**Letter of Objection to the development at Former Tower
Car Sales, Tower Close, East Grinstead, West Sussex (now known as
Whittaker House, 1 Leppard Walk) and
retrospective application DM/26/0432**

The promotional material (same images as submitted plans); the current front of the building;

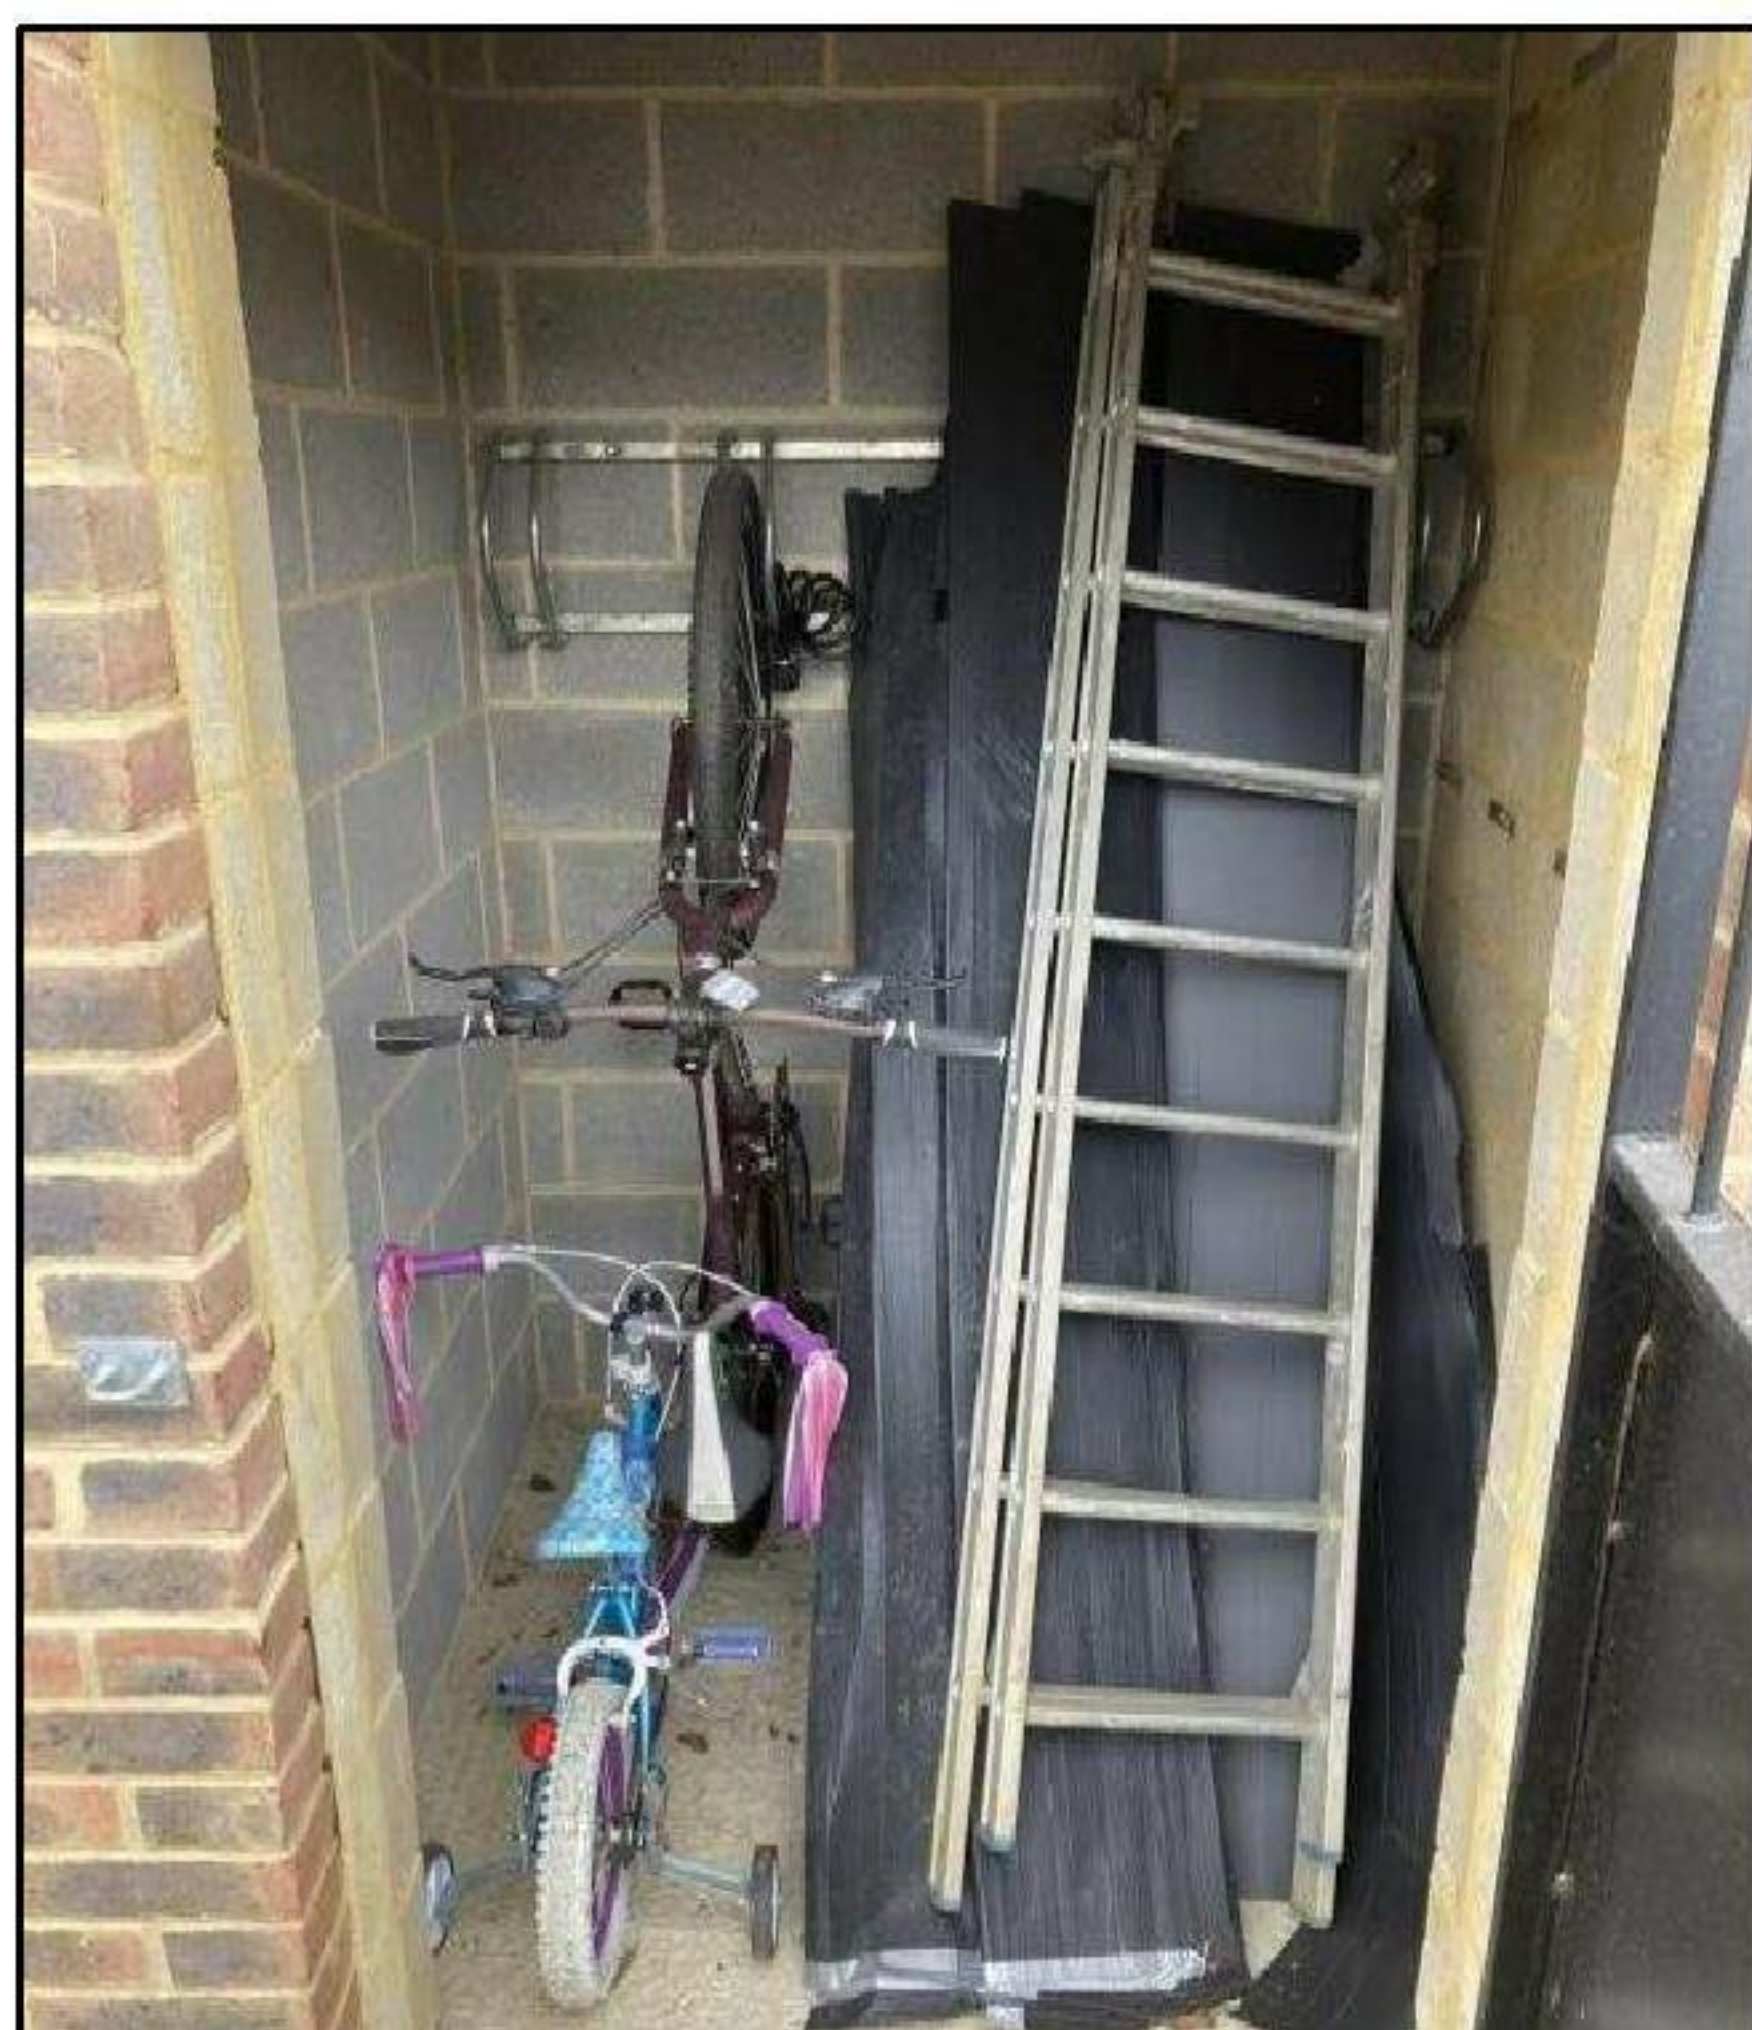
Starting with the outside of the property, Whittaker House was supposed to have a separate entrance, with a wide gated walkway to the right leading to a dedicated bike storage for 10 bikes, and 2 large refuse bins (sufficient bin storage for 8 properties). Both of these areas would lead into the entrance hallway, with the stairwell benefitting from opaque glass and entry into the undercroft.

Planning permission was granted with acknowledgement of this, and noting that residents would not have to enter through the undercroft:

The entrance is now our 'dedicated bin and bike storage'. These are so unsuitable for the purpose as to be functionally useless. They remain unfinished, with unfinished brickwork (and bin storage) now forming part of the view for our neighbours. The bin storage area is inadequate, holding 8 bins with a 9th squeezed in, while recycling bins are now stored in the undercroft because there is no proper dedicated refuse area. The bicycle storage is plainly incapable of accommodating 10 bicycles securely and bears no resemblance to what was approved or marketed to buyers.

Dedicated secure storage for 10 bikes; Dedicated bin storage

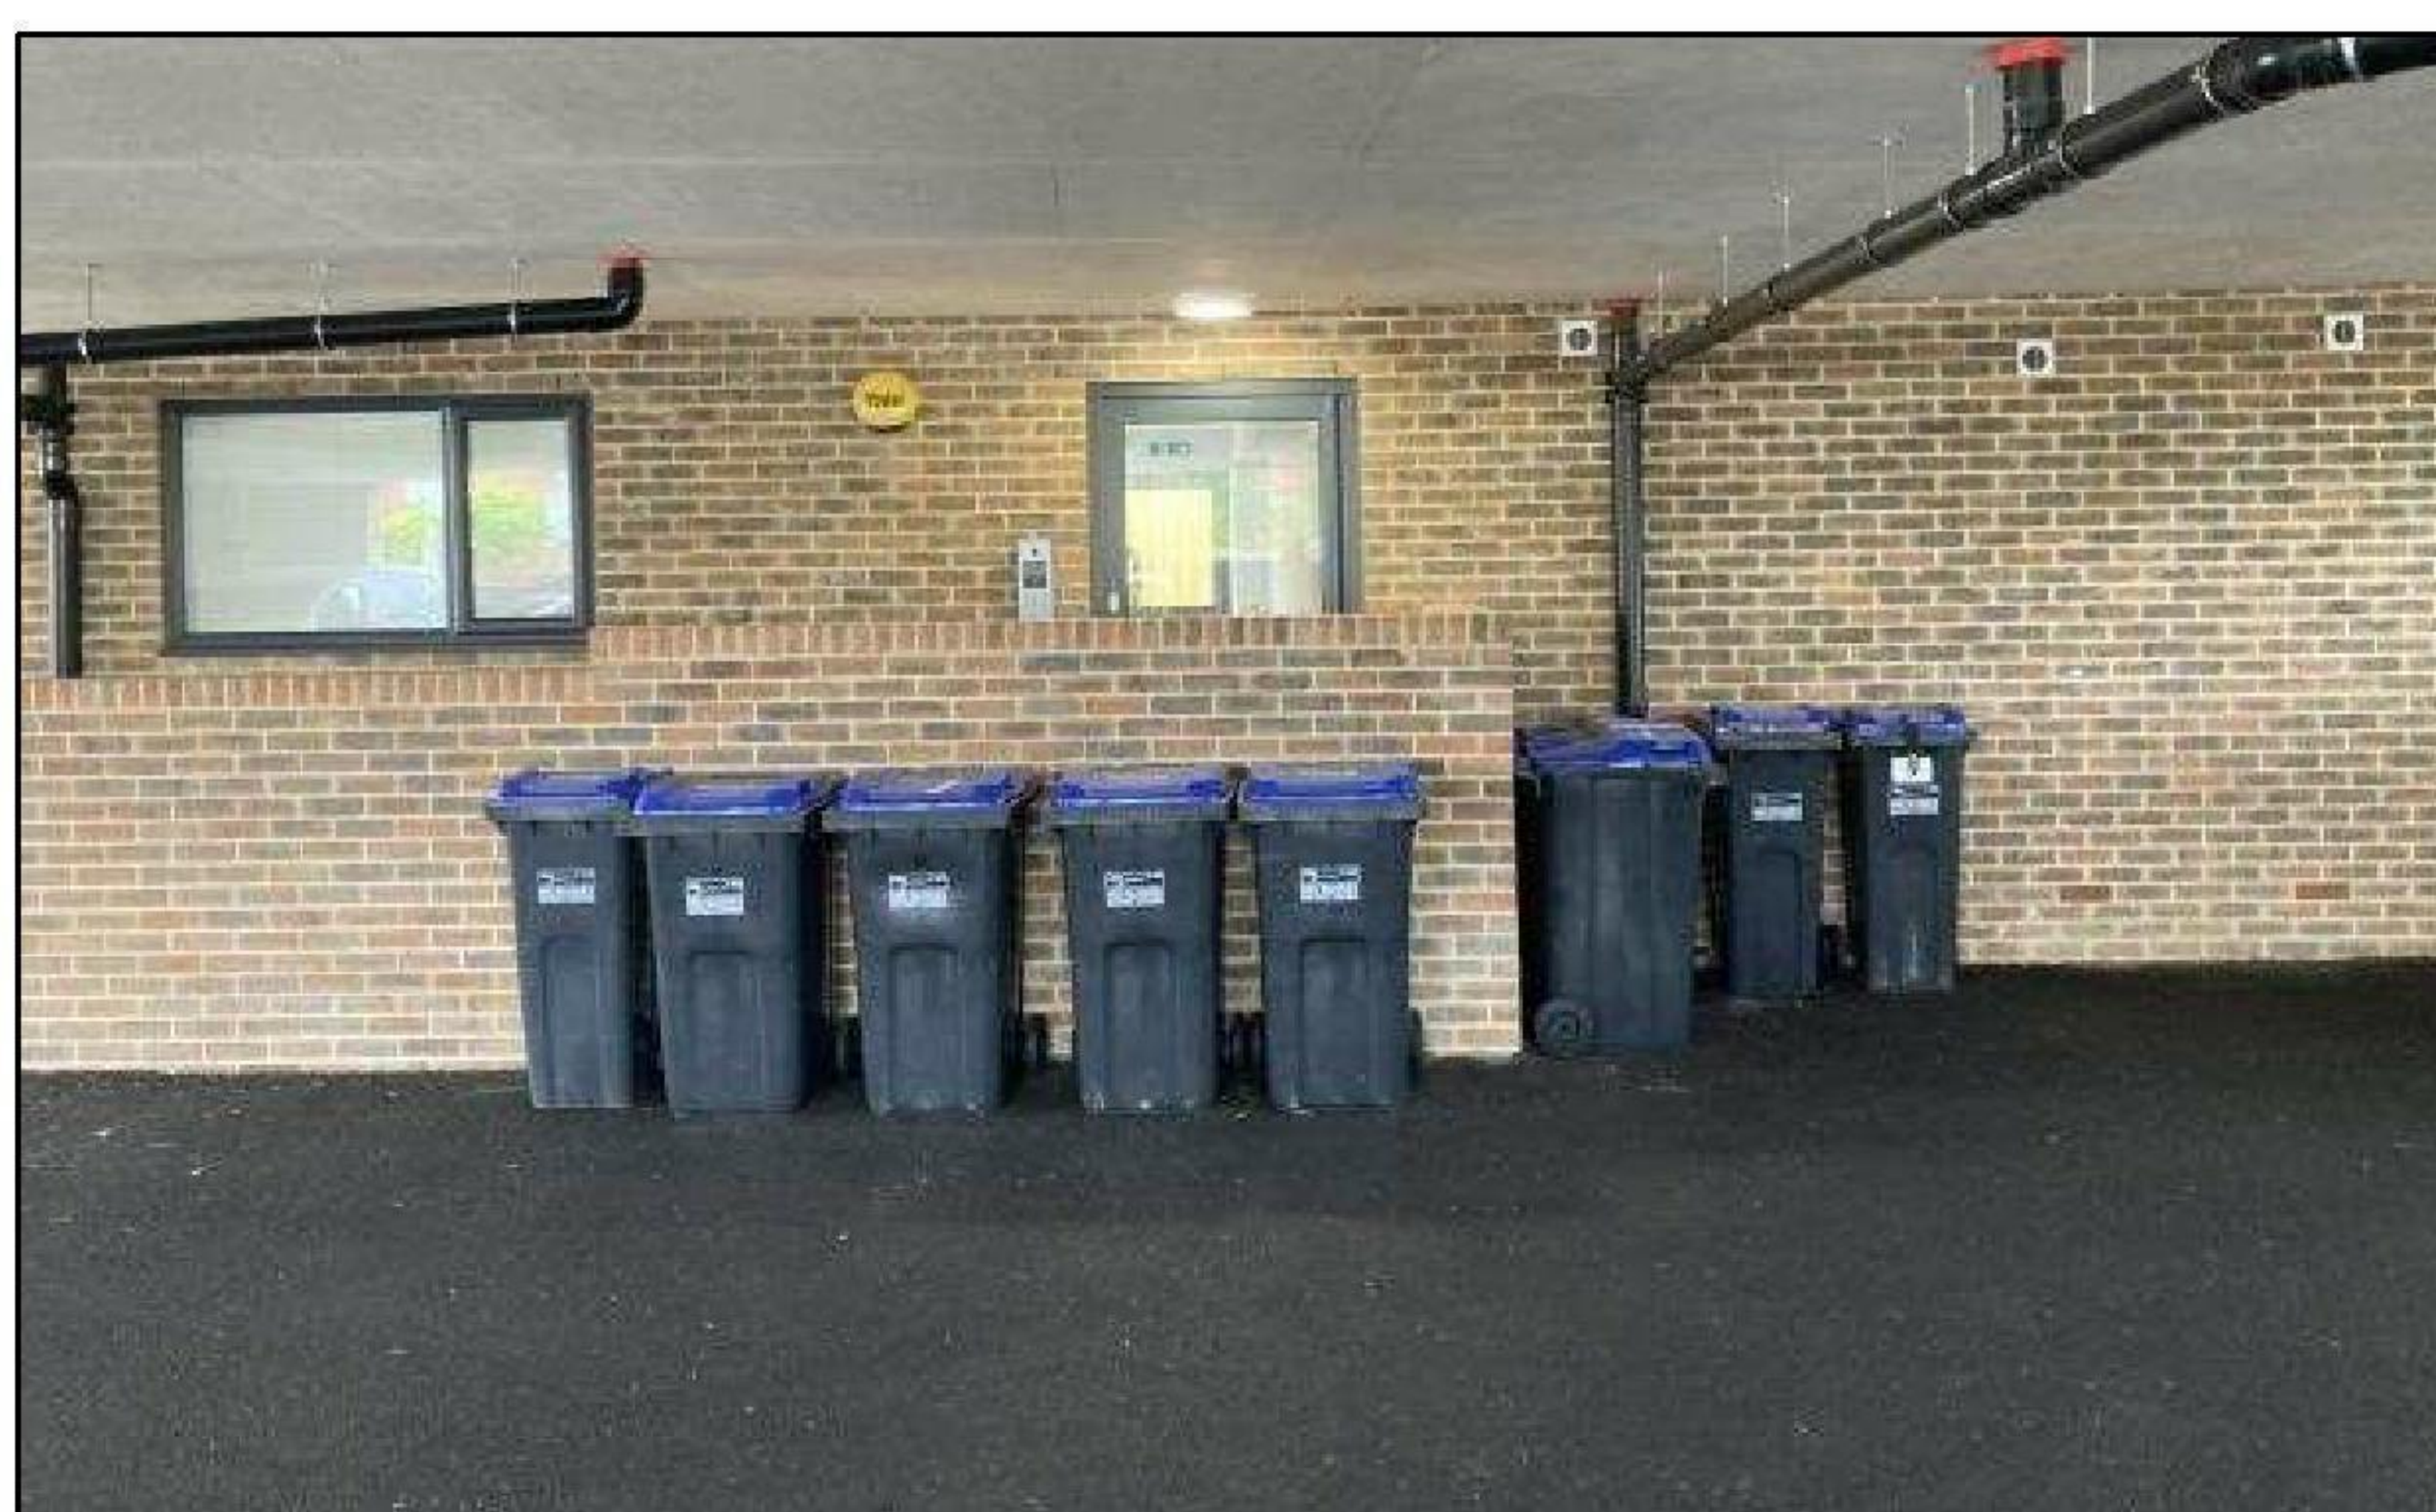
It would be funny if the property hadn't been marketed and sold as having dedicated secure bike storage, if said storage wasn't also mentioned when granting planning permission, and if several of the current freeholders hadn't purchased their property with this specific feature in mind.
